Guide bridge : Estimate of Rs 7450 for
Anshetkurga — in the 40 mile of road
No: 10 from Raunad to Dimpalpur in
the Madras, sanctioned with remark.

GOVERNMENT OF MADRAS.

PUBLIC WORKS DEPARTMENT.

Name of work... Constructing a Girder
Bridge in the 4th mile of
Road No 11. Ramnad to
Devipattanam. Madura District.
Est Rs 6,580.

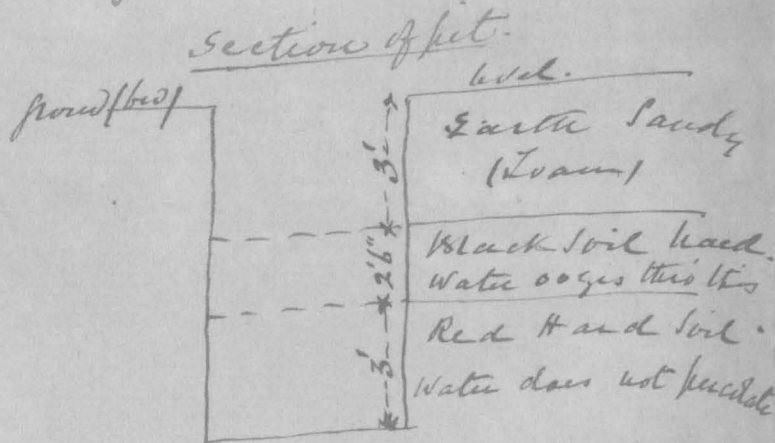
The bridge is to be con-
structed over one of the
outlets of the River Vaigai
which crosses the road.
There formerly existed an
arch bridge of 3 spans over
this outlet which is now in
ruins, the cause of collapse
is attributed by the District
Board Engineer

not to want of an apron to bridge.

2nd. The foundations of abutments of piers not being carried into firm soil but only up to it, which caused the gradual sinking of the right abutment, the subsequent thrust of the arches causing the ultimate destruction of the bridge.

Six trial pits have now been excavated across the outlet at proposed site of bridge and hard red soil into which water does not percolate is found 5'6" below the surface for 5 feet in depth, the soil above - black soil - for 2'6" in depth, & sandy earth for 3 feet up to ground level. It is proposed to carry the foundations of piers and abutment 2½ feet into this hard red soil which it is thought would be ample. The bridge has been designed with piers 3'6" broad (and foundations carried down to 32.92^{ft} with one footing 4'6" wide and concrete below 6'6" broad and 4'6" deep. The lower stream ends of piers have rounded ends

This may be so, but the very insufficient waterway of the old bridge, & consequently much head - ing up above it, & far too great velocity thro' the arches, is quite sufficient to account for the failure of a bridge unprotected by any flooring. Scour at foundations was inevitable during a major flood.

Yes, with the waterway now provided & with an apron, scour is not possible, & the new foundations proposed are ample.

and cutwaters only placed upstream side. A floor with triable retaining walls is allowed.
